Illinois Tollway Base Sheet Revisions			
Section M	Base Sheet Drawings		
	Drawing	Modification Summary	Effective: 03-31-2016
	All	The electronic (pdf) version of the Standard Drawing are now made searchable (text).	
Erosion Sediment Control (ESC)-Series 200			
M-ESC-205	Sediment Basin Dewatering Device		
	Revised Note 7, removed proprietary name from skimmer device.		
Roadway (RDY)-Series 400			
M-RDY-408	Approach Slab, Mainline		
All	Changed Transverse Reinforcement size and spacing in the bottom mat of the bridge approach slab and transition approach shoulder slabs from #6@9" to #8@4" to be in conformance with IDOT ABD Memo 15.8.		
All	Changed Transverse Reinforcement size and spacing in the top mat of the bridge approach slab and transition approach shoulder slabs from #5@12" to #5@6" to be in conformance with IDOT ABD Memo 15.8.		
All	Changed Longitudinal Reinforcement size and spacing in the top mat of the bridge approach slab and transition approach shoulder slabs from #4@15" to #5@6" to be in conformance with IDOT ABD Memo 15.8.

Tollway Base Sheet Revisions		
Section M	Base Sheet Drawings	
	Drawing	Modification Summary Effective: 03-31-2016
	Maintenance of Traffic (MOT)-Ser

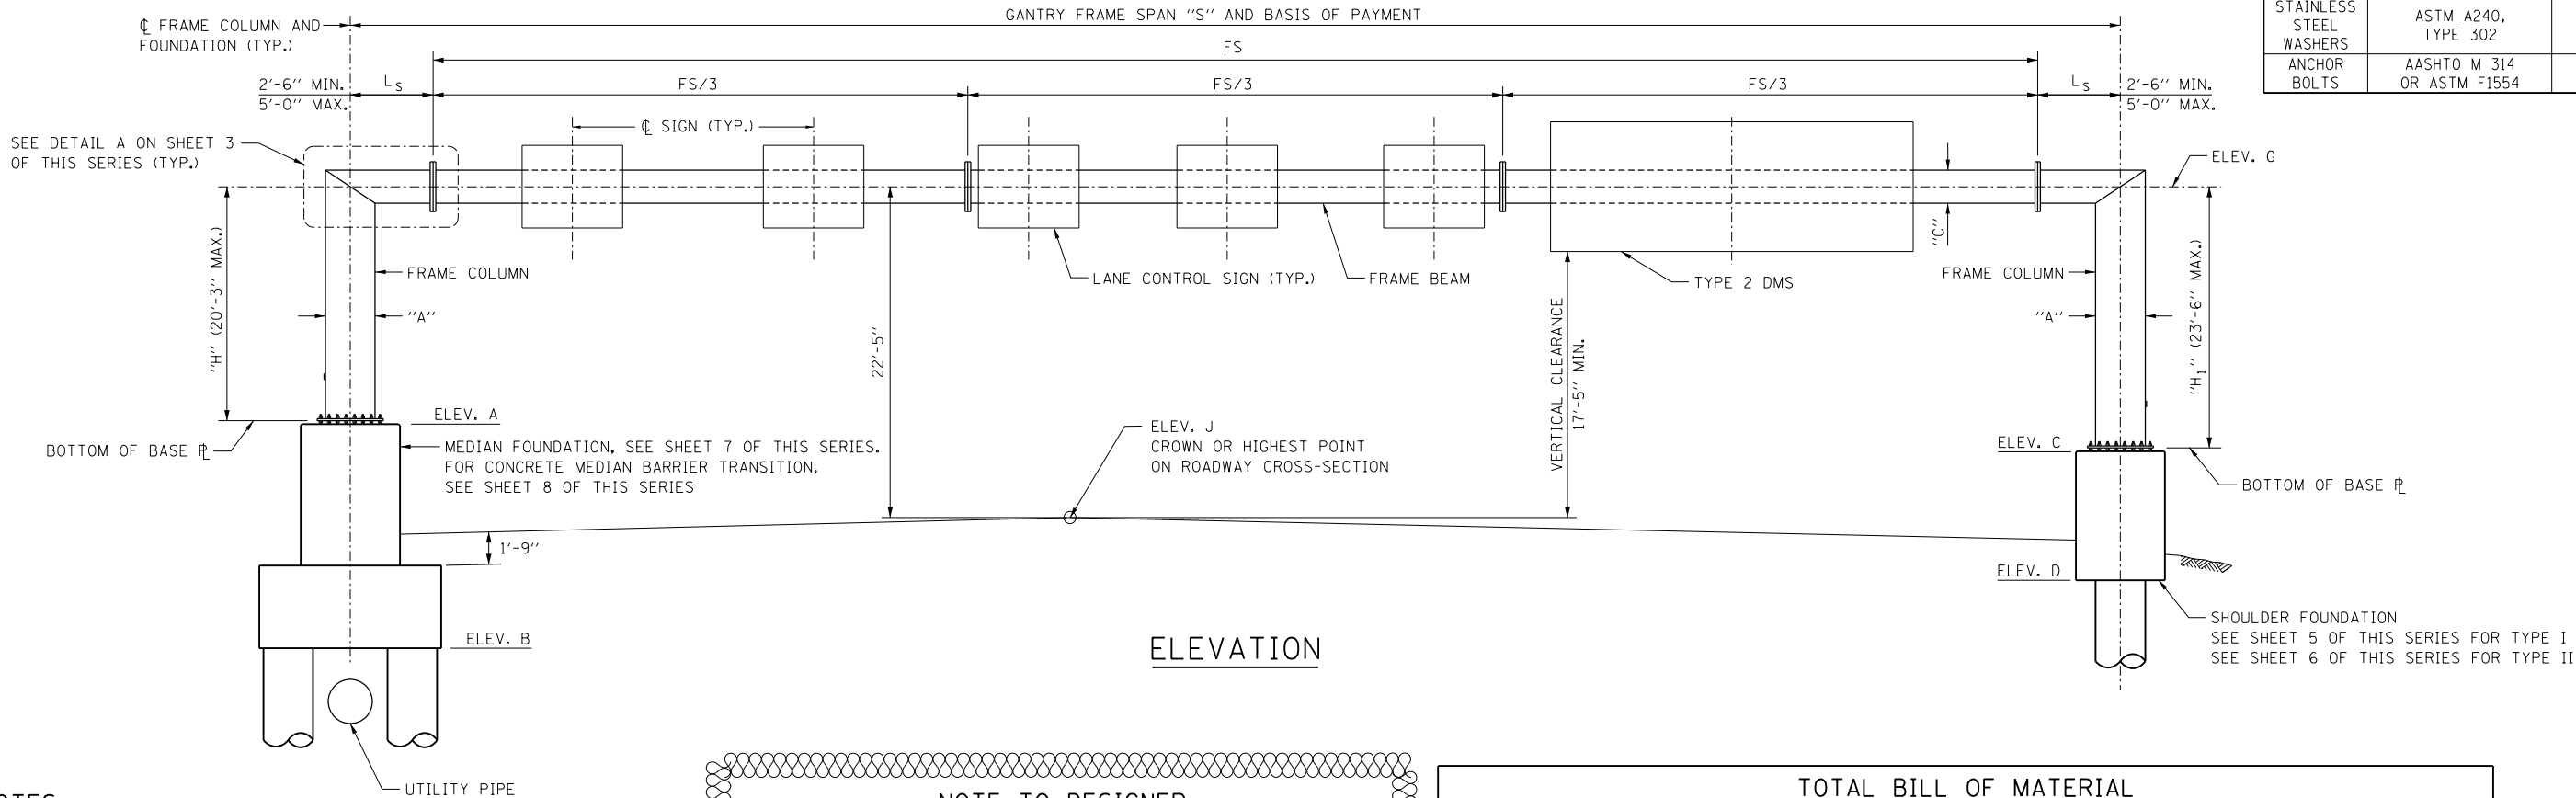
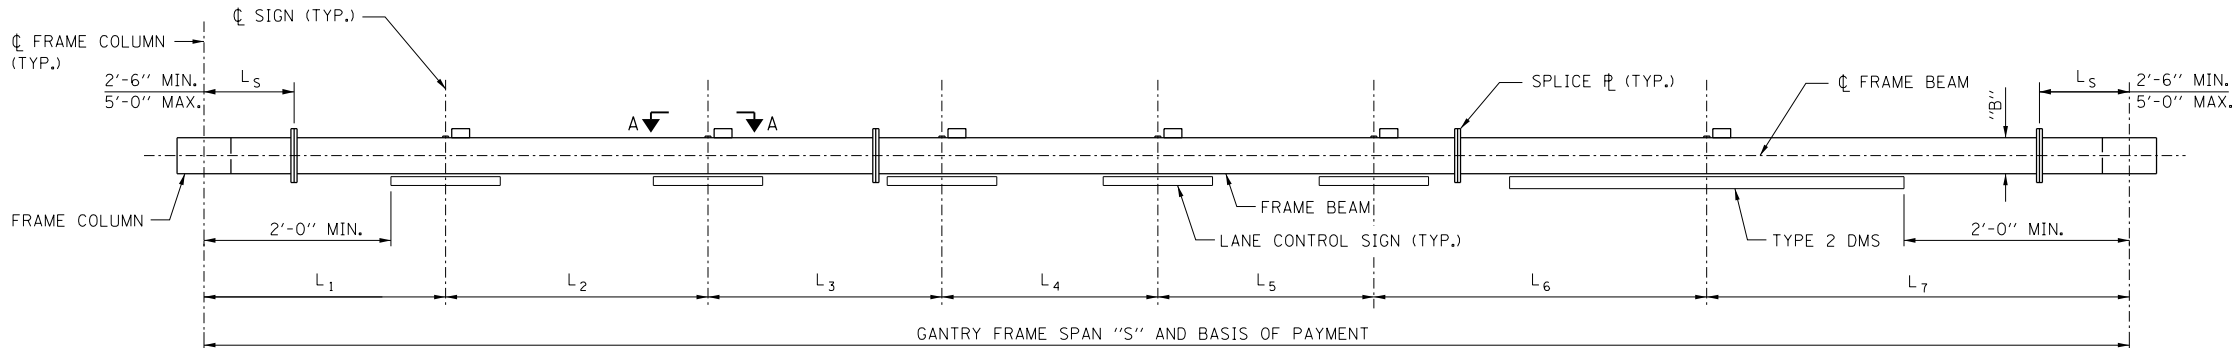
Sheet 1	Revised Material Specification Table to specify ASTM A500 Gr C & B for Frame & Mounting Beam HSS, respectively.
	Sheet 4	Removed Note 6, referring to ASTM requirements of HSS members.

BASE DRAWING M-OHS-729
SHEET 5 OF 8

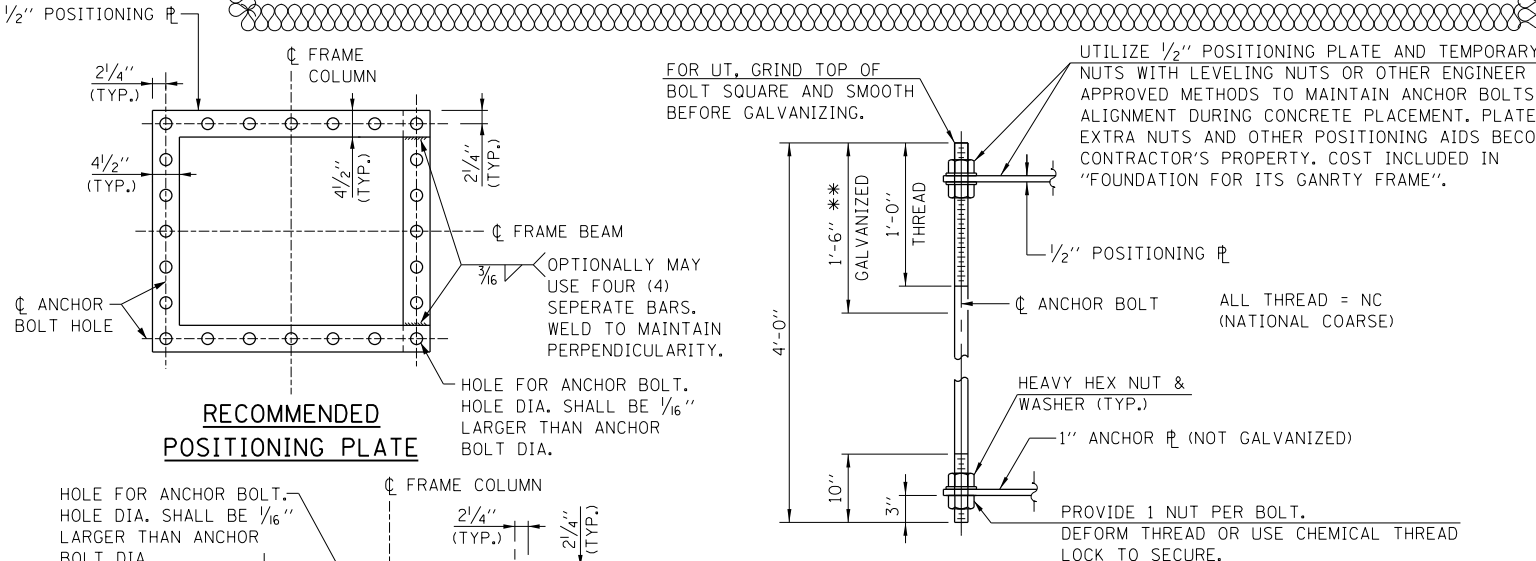
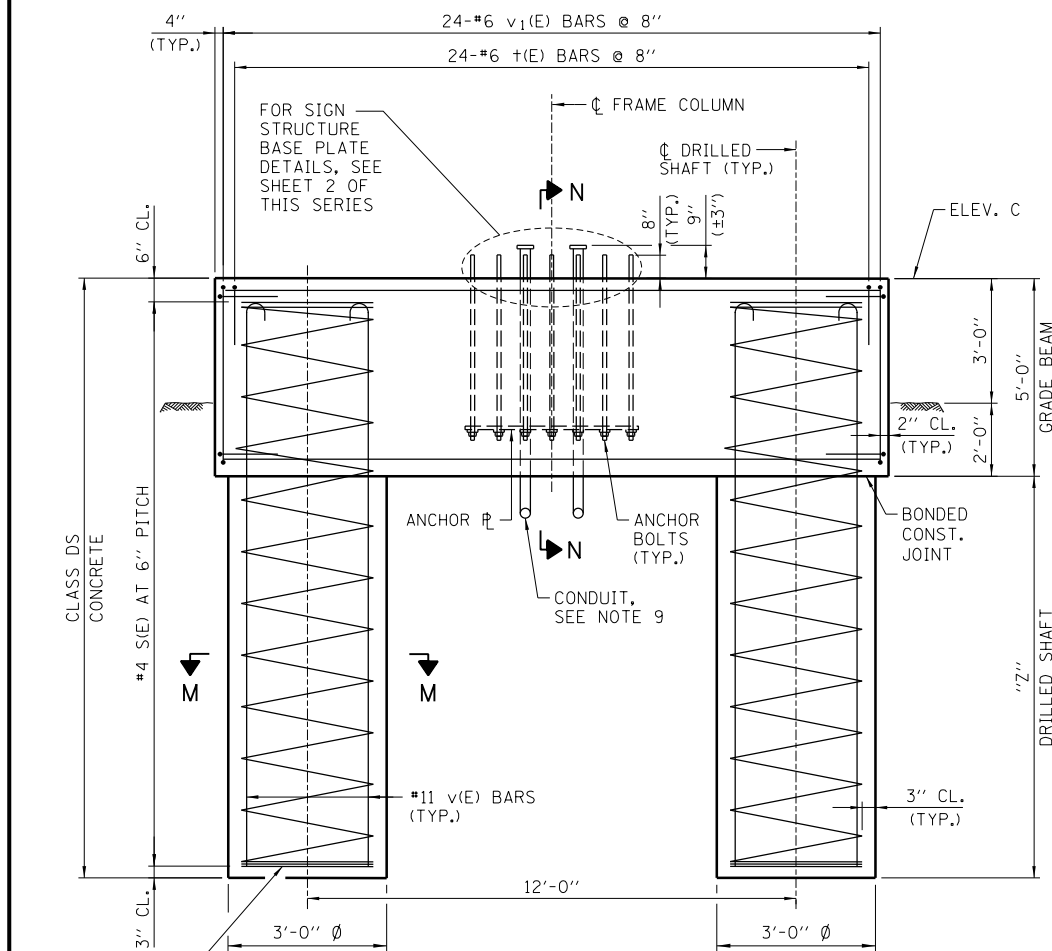
Sheet 5	Revised Note 1 to clarify requirements for Contractor when soil conditions are not met in the field.
	Sheet 5	Removed Protective Coat quantity since not required to be applied to shoulder foundation.

Sheet 5	Updated anchor bolt note to allow ASTM F1554 bolts.
	Sheet 6	Revised Note 1 to clarify requirements for Contractor when soil conditions are not met in the field.

SHEET 6 OF 8

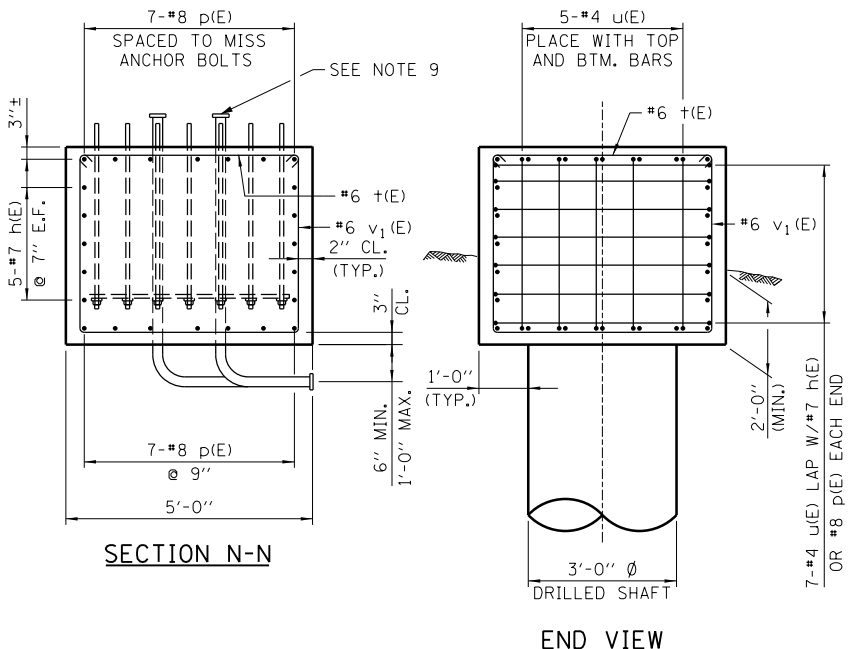
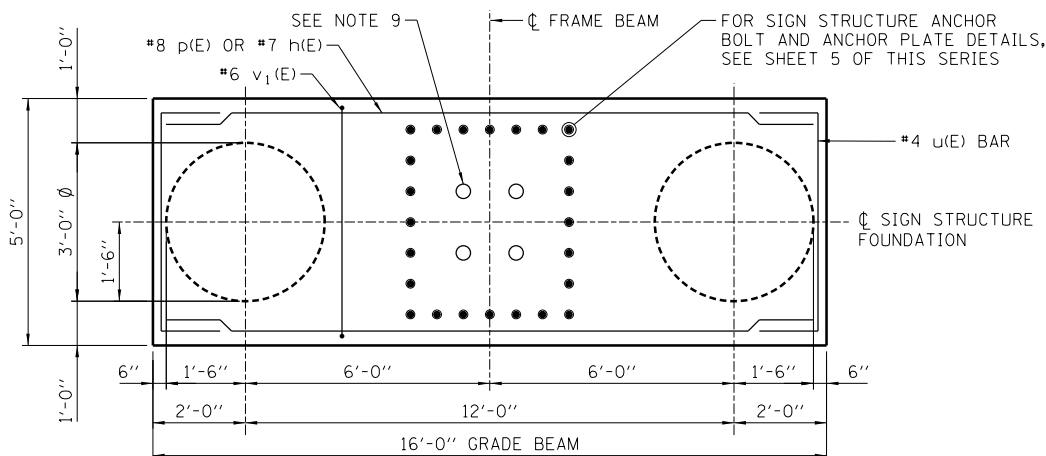
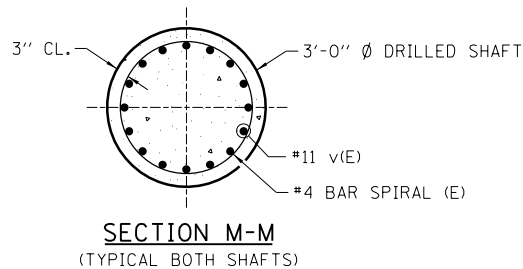
Sheet 6	Removed Protective Coat quantity since not required to be applied to shoulder foundation.
	Sheet 7	Added note 5 to clarify limits of protective coat and revised protective coat quantity in Median Foundation Schedule.
	M-OHS-730	Overhead Sign Structure ITS Gantry Frame (Steel) Two-Span Structure Details

BASE DRAWING M-OHS-730

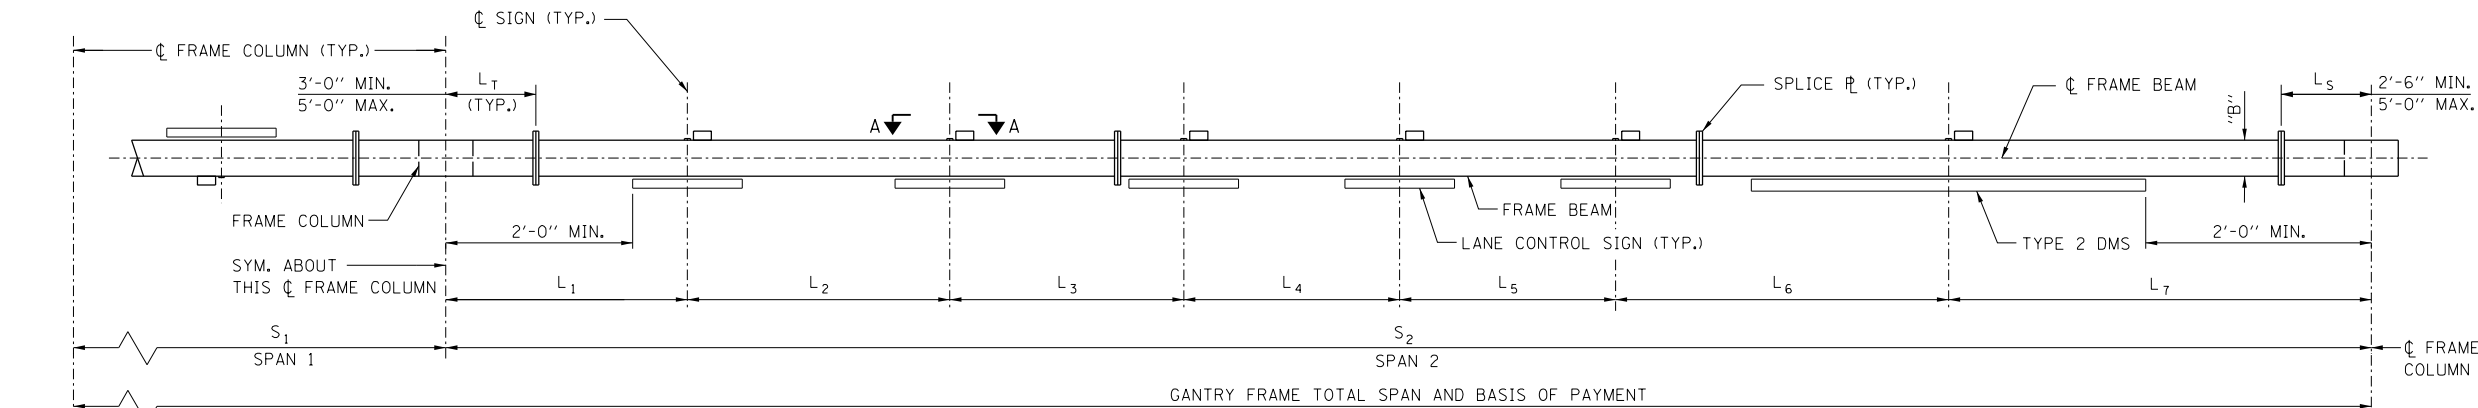
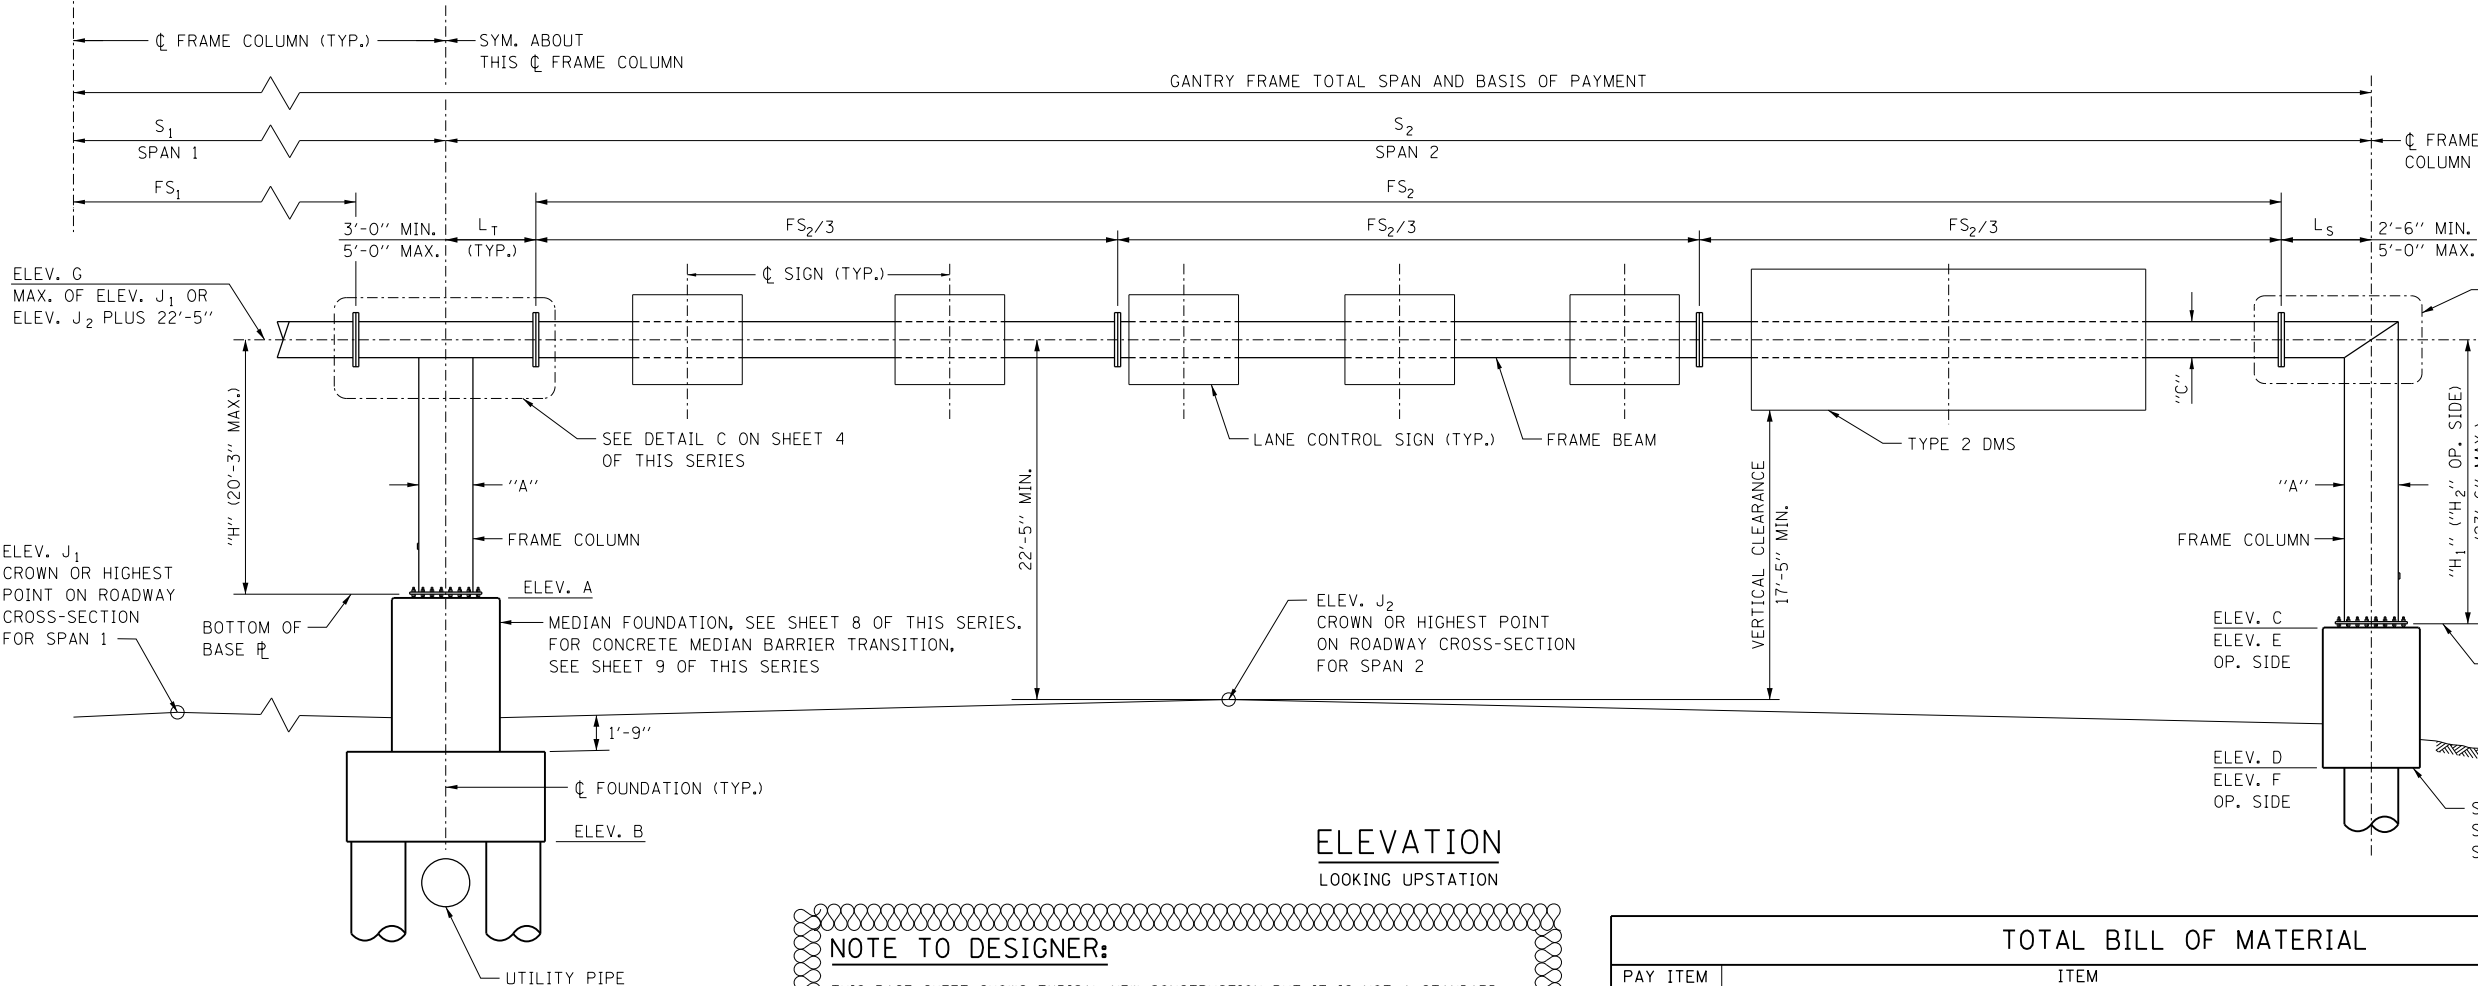
Sheet 1	Revised Material Specification Table to specify ASTM A500 Gr C & B for Frame & Mounting Beam HSS, respectively.
	Sheet 4	Removed Note 6, referring to ASTM requirements of HSS members.
